Access Compliance Report Public Rights-of-Way (Curb Ramps)

Main Street: O_NEILL_DR Cross Street: ETON_PL Location: S

ADA ID: RPRK211103154205 Ramp Type: Type 4 - Parallel Initial Pass/Fail: Fail Overall Compliance: No Severity Score: 2

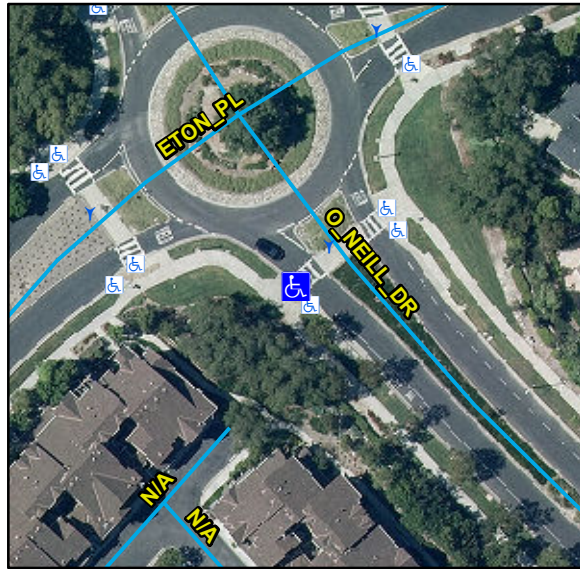
Remove & Replace Entire Ramp.

R304.2.2, R304.5.3, STD 1115
